**DATE:** October 20, 2015

**TITLE:** 1400 North Shoreline Boulevard Master Plan

## **PURPOSE**

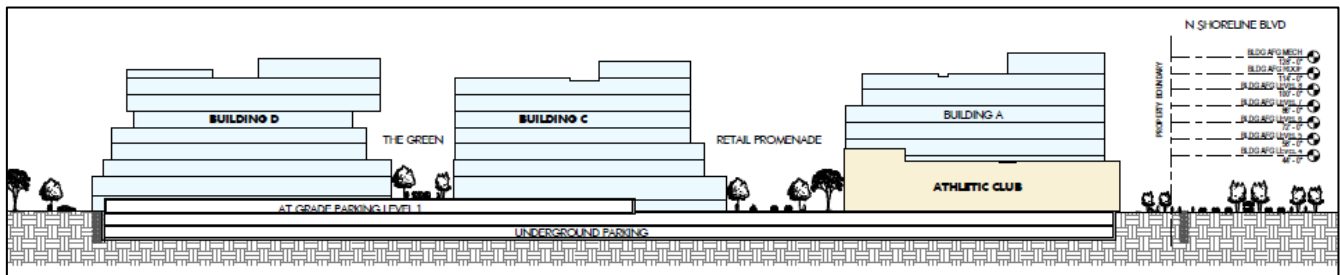
The EPC was supportive of the overall site design, access, and circulation. The EPC recommended the retail promenade extend to Plymouth Street with the Phase I development. The transit center should be designed to accommodate private and public shuttles, including the Mountain View shuttle. The applicant was encouraged to study how the central green and east green open space areas can be activated in such a way that after the office employees are gone it does not appear abandoned. Consideration should be made by the applicant to incorporate public art into the building design and to provide additional landscape and planting for the movie theater and athletic club at the corner of the site adjacent to Shoreline Boulevard and U.S. 101. The size of the proposed underground garage is very large and the circulation design, wayfinding, and signage are important for vehicles, pedestrians, and bicycles navigating in and out of the garage.

*Question No. 1: Does Council support the proposed site design, access, and circulation?*

*East/West Section (Interior Property Line to Shoreline Boulevard)*

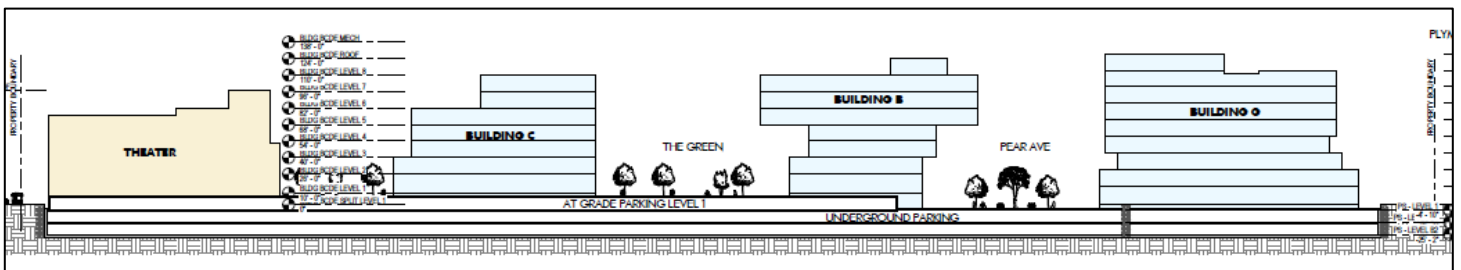
The EPC was generally supportive of the proposed building massing and articulation and recommended some refinements to the design. EPC requested the applicant provide light and shade studies for the open space areas. The open space areas may be in shade due to the proposed building massing. Consider the views of the mountains from the pedestrian level and not just from the upper levels of the office buildings. Continue to refine the building design for Buildings F and G facing Plymouth Street, particularly enhancing the pedestrian streetscape. Also, continue to refine the building design for the athletic club and movie theater to be more inviting and pedestrian friendly. The large movie theater roof may be an ideal location for photovoltaic installation. The EPC also encouraged the applicant to consider incorporating a publicly accessible roof terrace into the project. All of the proposed roof terraces are proposed for private use only.

*Question No. 2: Does Council support the overall building massing and heights?*
